DOCKETED	
Docket Number:	23-AFC-02
Project Title:	Elmore North Geothermal Project (ENGP)
TN #:	260730
Document Title:	Staff Response to Committee Orders
Description:	Staff Response to Request for Information Regarding Cultural and Tribal Cultural Resources
Filer:	susan fleming
Organization:	California Energy Commission
Submitter Role:	Commission Staff
Submission Date:	12/18/2024 5:04:08 PM
Docketed Date:	12/19/2024

Elmore North Geothermal Project

Staff's Response to: REQUEST FOR INFORMATION REGARDING CULTURAL AND TRIBAL CULTURAL RESOURCES

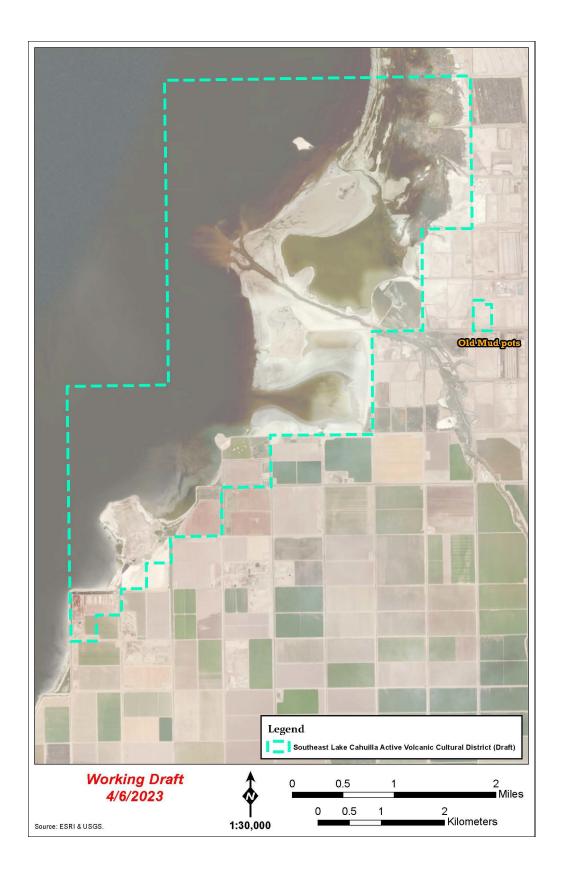
Analysis of the evidence supporting the boundaries of the Cultural District as currently proposed. Nothing herein is directing the filing or public disclosure of confidential information. Confidential information may be discussed in general terms as appropriate. Additionally, to the extent necessary to support the proposed boundaries, Staff shall, and the other Parties may to the extent known to them, cite material filed in the dockets of the proceedings designated as confidential without publicly disclosing the information.

Again, the full evaluation and expression of the results of staff's analysis is appropriately included in the FSA, and these preliminary remarks are subject to change. Based on current data, the Cultural District consists of two discontiguous units (Figure 5.4-2), units A and B. The former contains the five volcanic domes of Obsidian Butte, Rock Hill, Red Island, and Mullet Island; two areas of Mud Volcanoes and Mud Pots (CA-IMP-003256H and The New Mud Pots and Volcanoes); a Pond of Good Water (CA-IMP-3251H); and the Saltwater Pond (CA-IMP-003255). Unit B contains the Mud Volcanoes and Old Mud Pots (CA-IMP-003257H). (TN 257697, page 5.4-50; see figure below.)

The Cultural District incorporates the main cultural features of the Salton Buttes: Obsidian Butte, Rock Hill, Red Hill, Mullet Island, the sets of mud pots, as well as their physical and visual connectivity, and setting. The boundary shape is drawn from information presented to CEC cultural staff by tribal representatives during the consultation process. The Cultural District boundary roughly follows the Salton Sea Shallow Geothermal Anomaly, although it is depicted with a smaller footprint. Because the water line for the Salton Sea is not static, the delineation of boundary lines mostly corresponds with United States Geological Survey guadrangle map section and section subdivision lines, which is consistent with the Native American Heritage Commission practices for Sacred Lands File searches. The Salton Sea contributes to the district by creating a visual setting resembling Lake Cahuilla in pre-contact times. Future identification of additional contributing and character defining features and buffers from potential incompatible uses, as defined by the perspective of the living traditional community (local tribes), may result in adjustment of boundaries in the future. Given the dynamic nature of this landscape, boundaries also consider fluctuations in the water line of the sea. (TN 257697, page 5.4-53.)
